**REMARKS**

Application No. 10/083,760  
Amendment dated June 8, 2004  
Reply to Office Action dated April 27, 2004

Fig.2

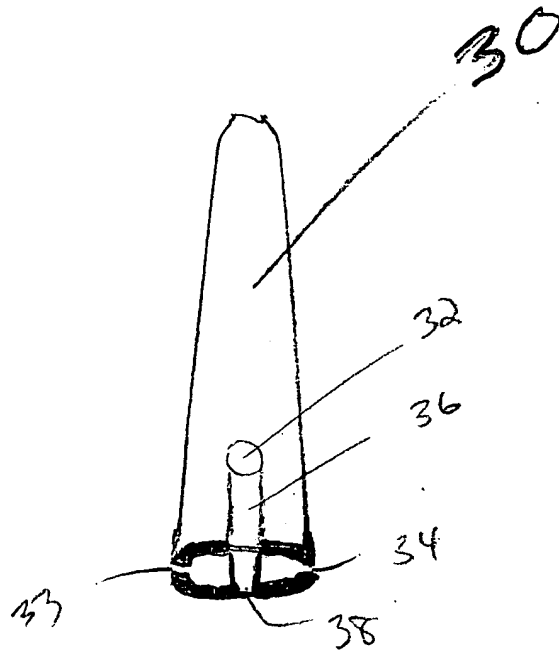
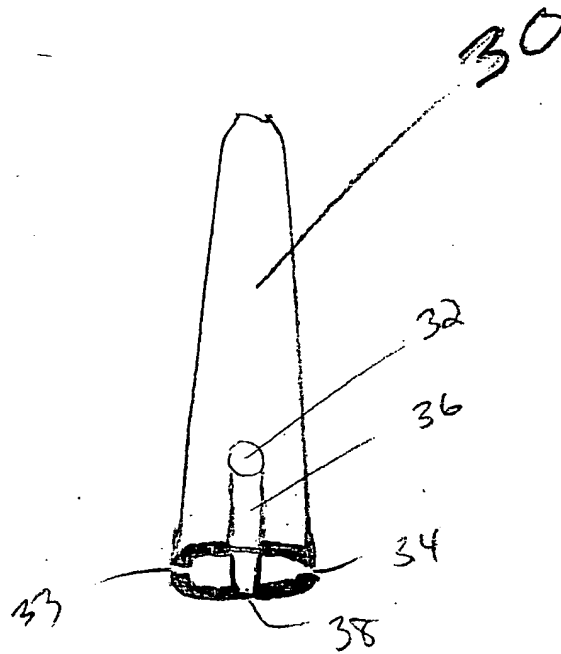
In paragraph 2 of the Office Action, the Examiner has objected to the drawings under 37 CFR 1.83(a) because the rivet head channel is not shown in the drawings.

Upon review of Fig. 2, rivet back channel 38, although partially illustrated, is not shown in full. Rivet back channel 38 as described on page 6, paragraph [0015] of the specification, is similar to rivet head channel 36 except that it is located on the back side of cover 30.

As shown in Fig. 2, the reduced thickness at the open end of cover 30 is shown for rivet head channel 38, but the rest of the channel extending up towards the closed end of cover 30 was inadvertently not shown. As such, Applicant has amended Fig. 2 to show rivet back channel 38 extending away from the open end of cover 30 towards the closed end of cover 30, until it disappears behind the top of cover 30. This amendment Fig. 2 more clearly illustrates the element as described and more closely corresponds to the other rendition of rivet back channel 38 shown in Fig. 4.

This feature of a rivet head channel is shown in Fig. 2, properly identified as

element 36, where a channel is shown extending from the open end of the cover to the rivet head receiving slot 32. Additionally, the angled front view of figure 2 shows the open end of cover 30 having a first thickness and the rivet head channel 36 having a second lesser thickness. The rivet head channel is also illustrated in different views in both Figs. 3 and 4.

In view of the foregoing, Applicant respectfully submits that the Amended Fig. 2 properly shows all of the described and claimed elements and requests that the objection to the drawings be withdrawn. Applicant further notes that pages 5 and 6 of the specification adequately support the drawings amendments, and that no new matter has

Fig. 4

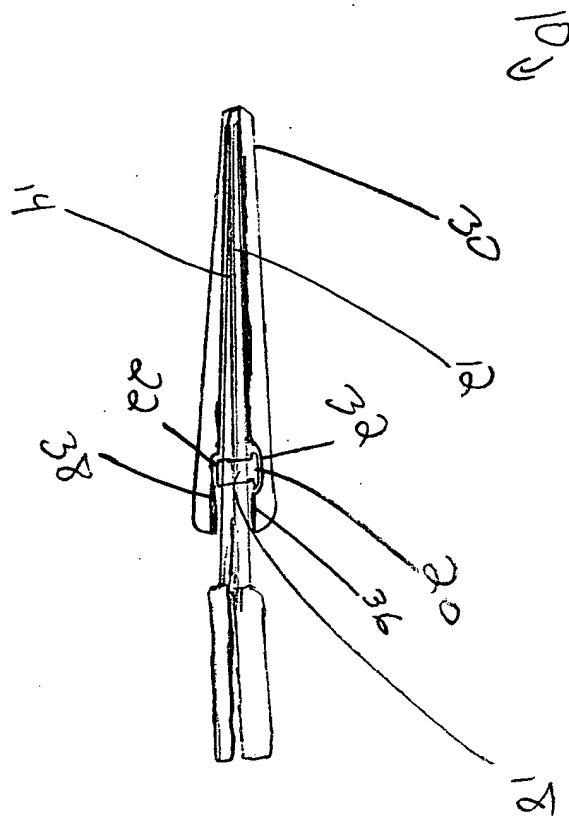
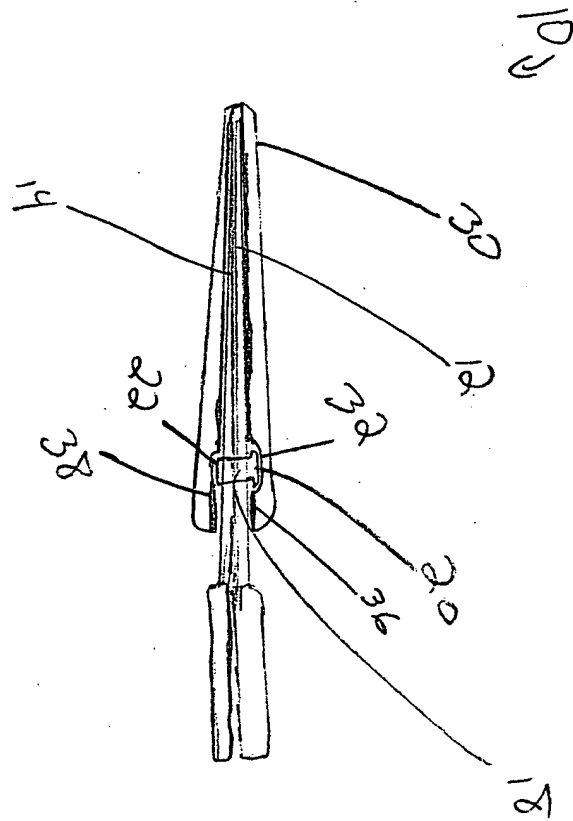
In paragraph 1 of the Office Action, the Examiner has objected to the specification because the element identifier “22”, on page 5 is missing from the drawings. Applicant has amended paragraph [0011] of the specification to indicate that element 22 is illustrated in Fig. 4, and the corresponding element identifier “22” has been added to Fig. 4. As such, Applicant respectfully requests that the objection to the specification be withdrawn.
